Docket No. 50-423
B11878

Millstone Nuclear Power Station, Unit No. 3
Revised Responses to Seismic Qualification Review Team (SQRT) Audit Questions

Attachment I
Status of SORT Audit Questions

FIGURE 1

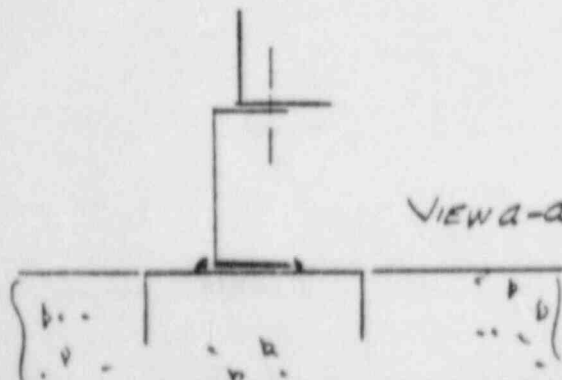
Question 1:

Demonstrate adequacy of the structural connections.

In order to address the adequacy of the structural connections in the main control boards, a calculation (12179.34 - NM(s) - 784 - CZC) has been performed. This analysis is preliminary and is attached for your information. As you will notice this is a QA Category I calculation and will be reviewed and approved in accordance with established QA procedures. The calculation has several attachments which are not included here. They are excerpts from an extensive weld reinspection and reevaluation program to address deficiencies in Reliance equipment. Reliance has agreed to make their original calculations available for review at their offices if necessary. However, the attached calculation adequately addresses connection design.

THIS ANALYSIS IS PERFORMED TO VERIFY THE ADEQUACY OF THE WELDED CONNECTION DETAILS AND TO EVALUATE THE COMPOSITE ACTION OF BUILT UP ATTACHMENT AT THE BASE OF THE MAIN CONTROL BOARD. REFER TO FIGURE 1 FOR DETAILS OF THE COMPOSITE SECTION.

VIEW a-a - BASE COMPOSITE SECTION

FIGURE 2

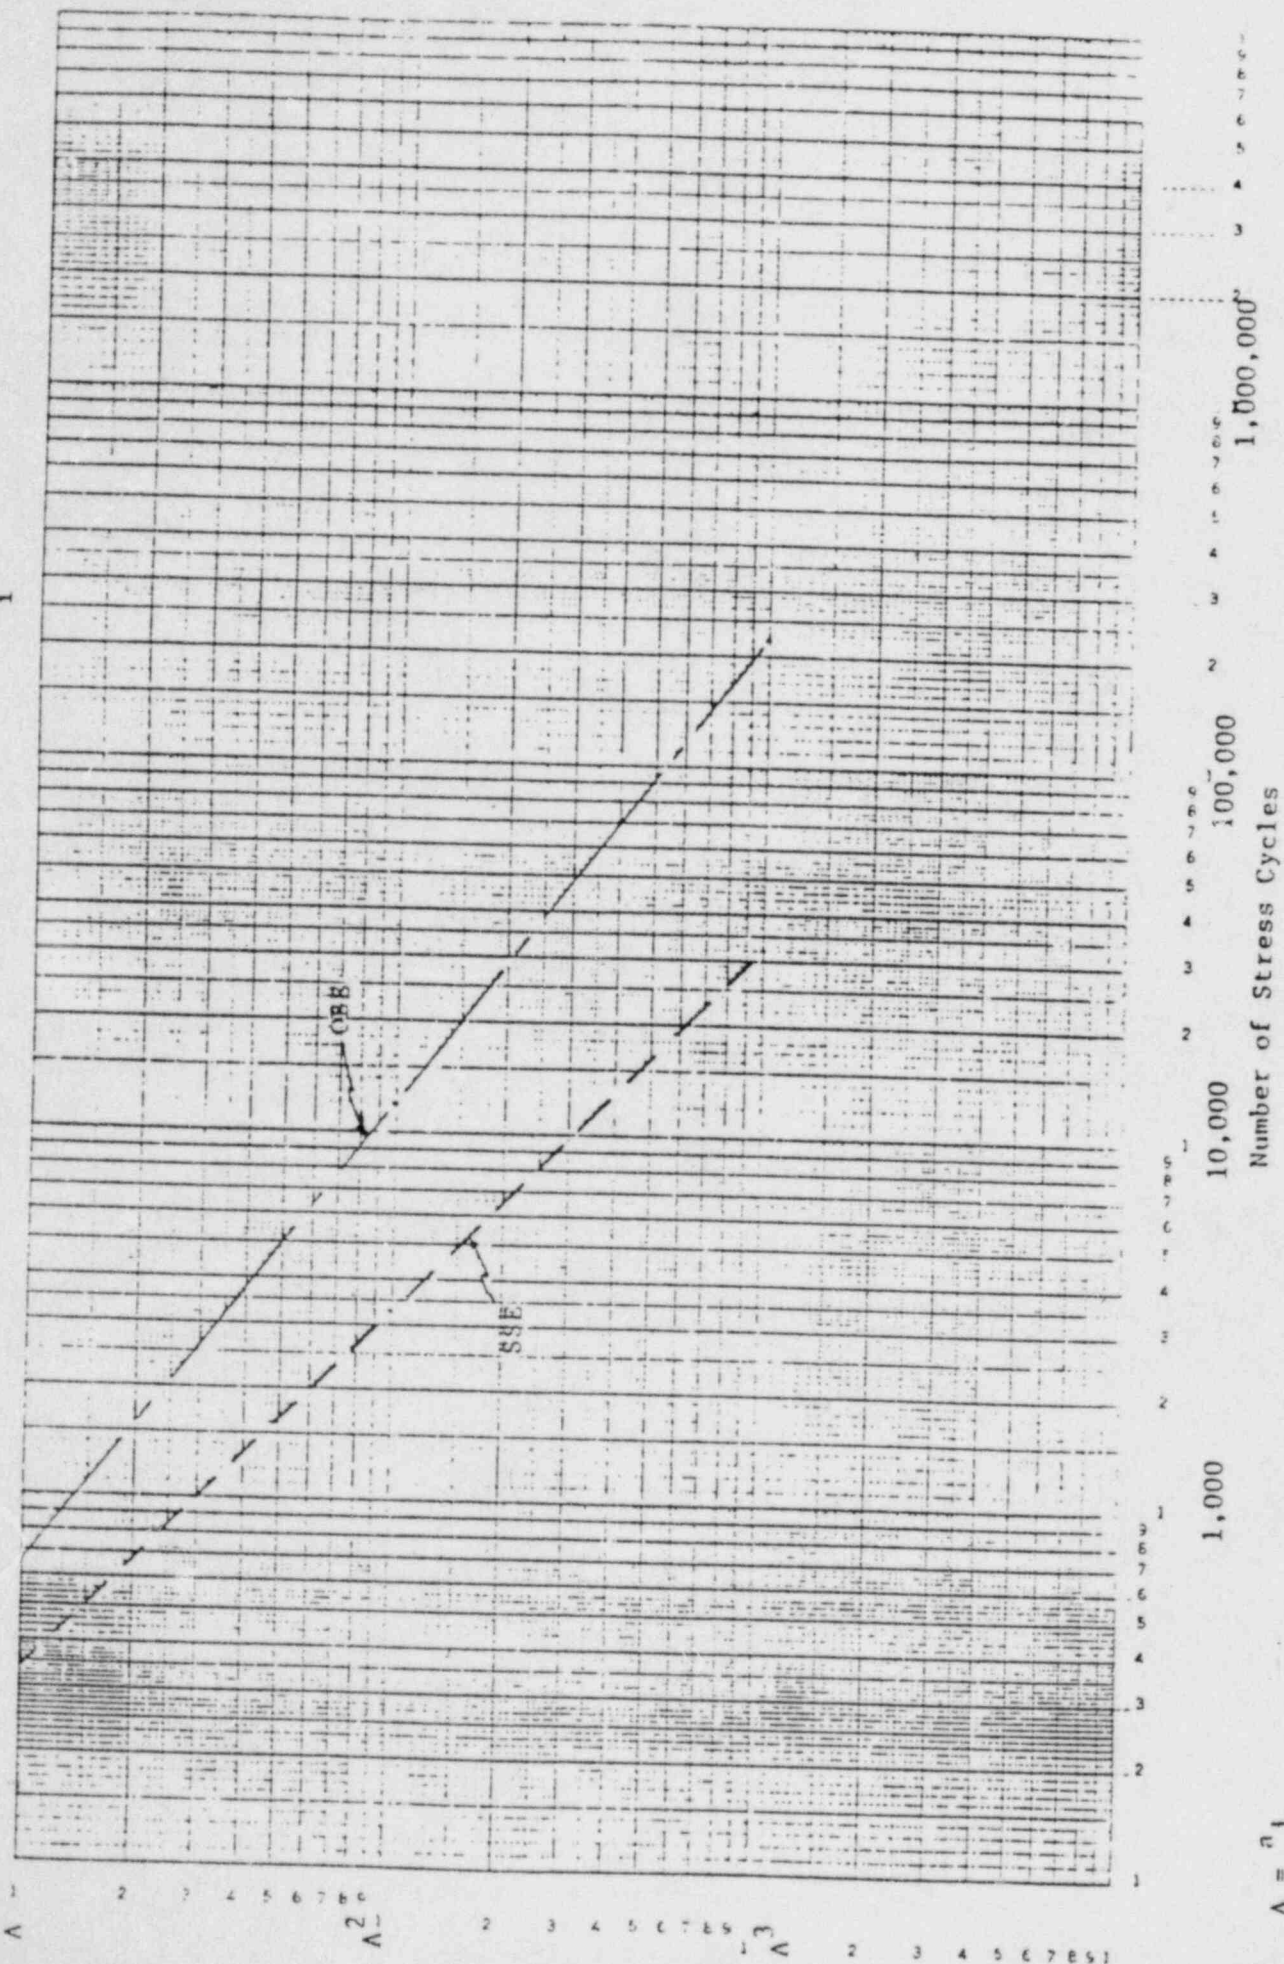
Provide additional justification on a time duration basis that the seismic tests performed for the NIS console provided the equivalent of 5 OBEs and 1 SSE at the resonance of the equipment (5 Hz) for the Millstone Unit No. 3 application. The assumption that fatigue damage at any acceleration for non-metallic materials is proportional to the cube or square of the acceleration level may not be conservative.

The equivalent stress cycles for the unity case can be obtained by plotting the equivalent number of cycles verse A^3 and A^2 on a log scale and extrapolating (see Figure 2). The results of performing the extrapolation are listed below:

Therefore based on the above comparisons and the additional testing performed prior to the "High Seismic" Level test (used for the Millstone Unit No. 3 qualification comparison), it is concluded that the equivalent test fatigue stress cycles which the NIS console experienced exceed the Millstone Unit No. 3 required fatigue stress cycles.

SKETCH-SK-RTSMG-NEU-01

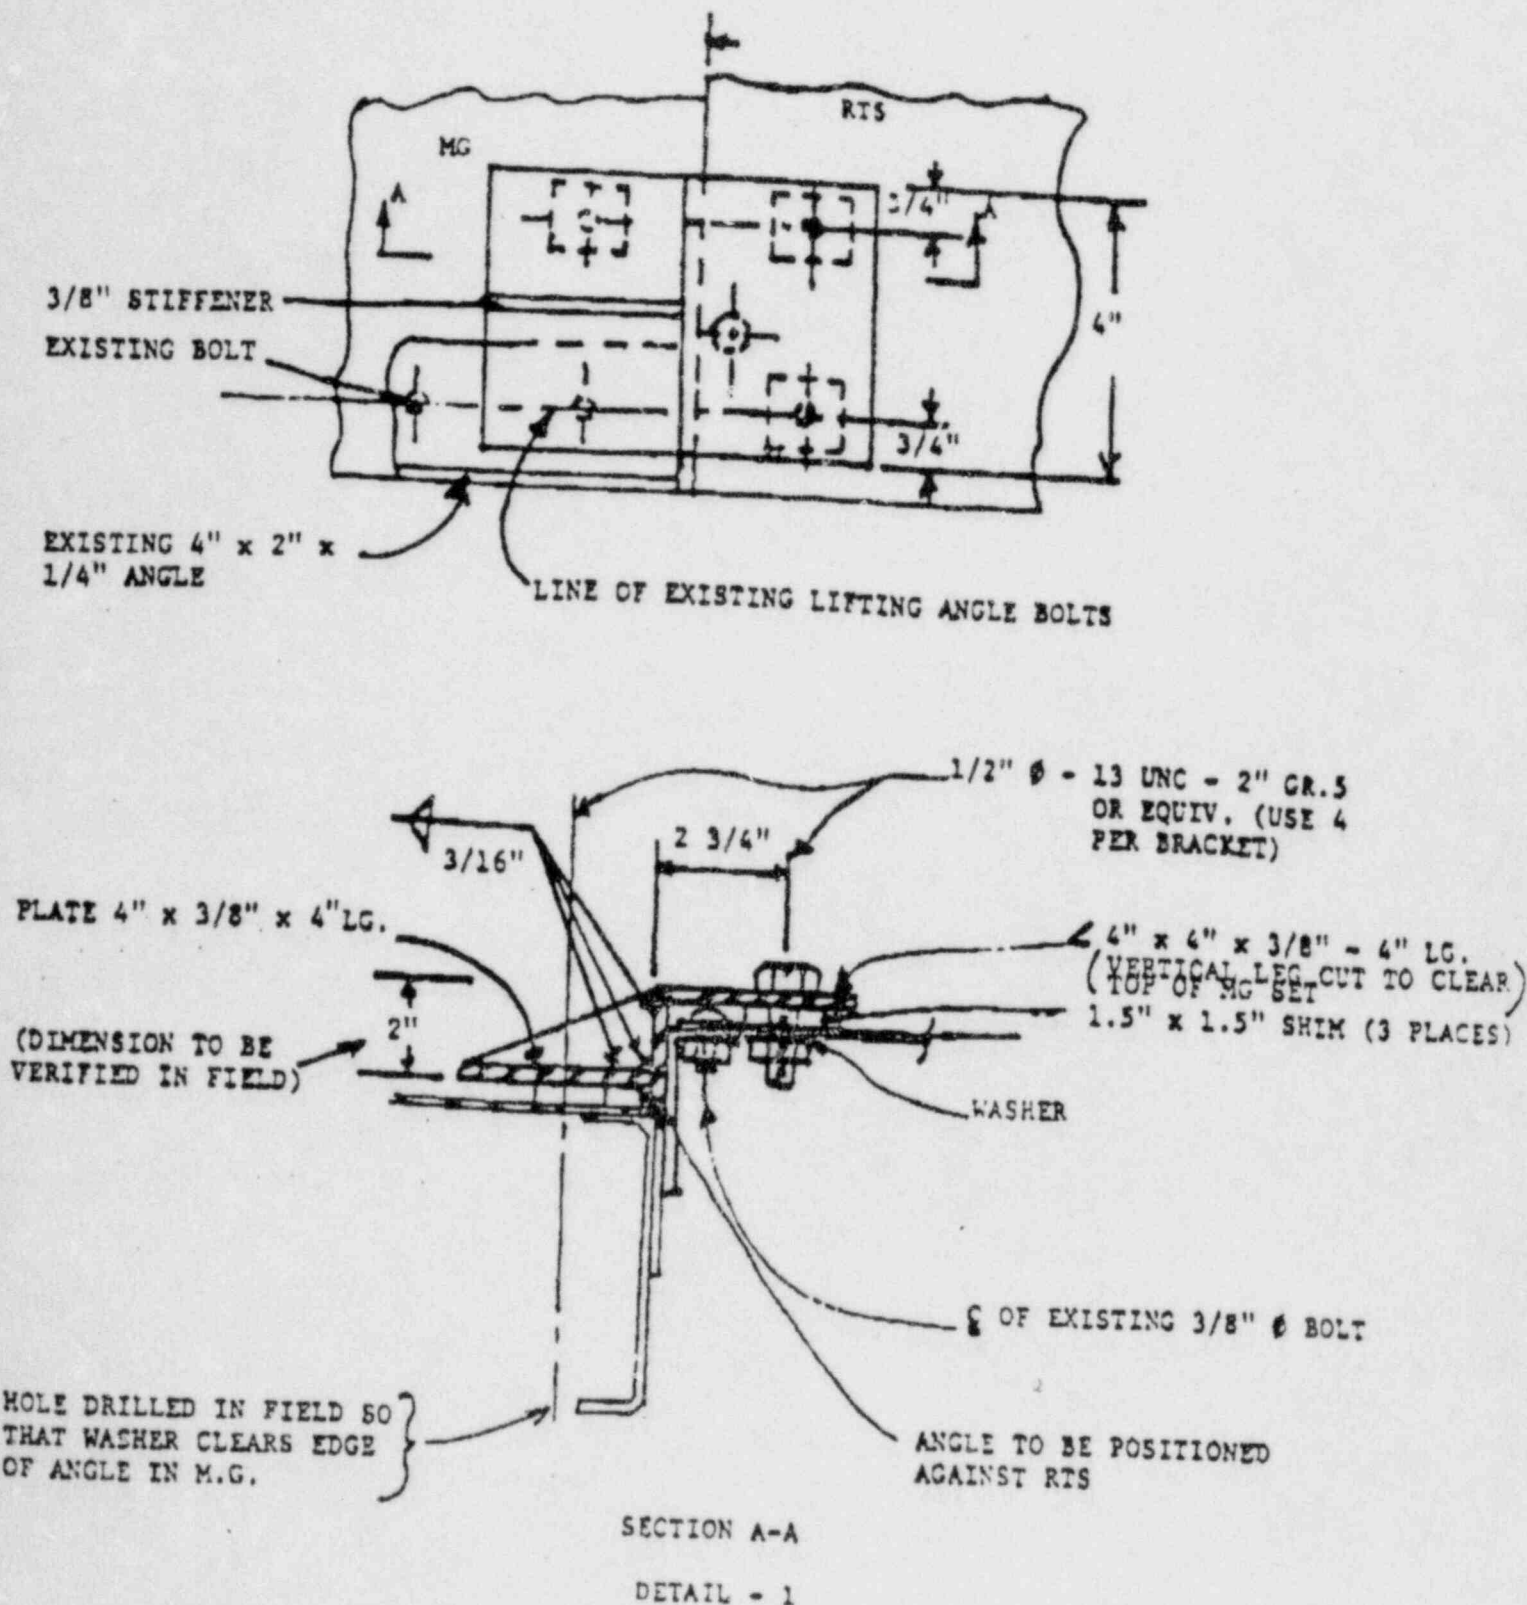
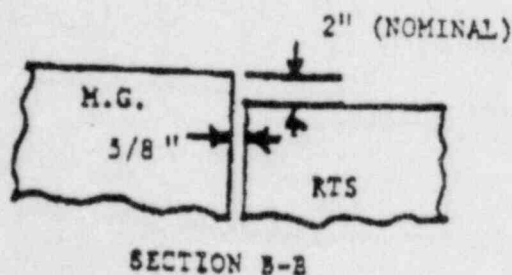
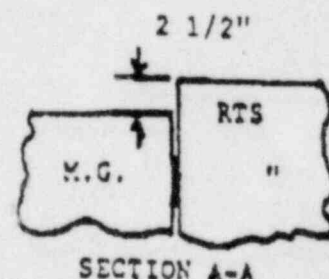
THE NRC SEISMIC QUALIFICATION REVIEW TEAM (SQRT) IDENTIFIED THE PHYSICAL SEPARATION OF CATEGORY I ELECTRICAL CABINETS AS A CONFIRMATORY ITEM AND GENERAL IN NATURE. INADEQUATE SEPARATION MAY CAUSE ADJACENT ELECTRICAL CABINETS TO IMPACT AGAINST EACH OTHER DUE TO SEISMIC INERTIAL LOADS. THE WESTINGHOUSE REKTER TRIP SWITCHGEAR (3RPSXSWG1 & 2) ARE IN CONTACT WITH THEIR 3RDS-MG/A & B CATEGORY II CABINETS. PROVIDE SUFFICIENT CLEARANCE BETWEEN THESE CABINETS OR HARDWARE DETAILS TO STRAP THE CABINETS TOGETHER.

As presently installed, the Reactor Trip Switchgear and Rod Drive control cabinet are bolted together at the base by means of busbars while the tops of the cabinets are free to move independently. Based on an evaluation of the seismic response of this equipment, it was concluded that the seismic qualification of the switchgear would be maintained if the two cabinets were joined to each other to ensure that the two units would move together to eliminate the possibility of inter-cabinet impacting. Based on the measurements provided by Stone and Webster in Ref. 1, two brackets were designed to tie the two cabinets together. The details of the brackets are shown in the following sketches:

1. Disconnect all power.
2. Work areas are identified in details 1-2.
3. Prepare the front bracket assembly prior to mounting on the RT8/Control Cabinet lineup. Since no clearance exists in the front between the units, the vertical leg (4") of angle must be shortened to clear top of MG set when positioned as shown in detail 1. The exact vertical location of 4" x 3/8" plate relative to vertical leg of angle must be determined in field. The attached sketch shows the nominal location. Mount the bracket assembly on the equipment and drill holes at location identified. Secure the brackets with specified hardware.
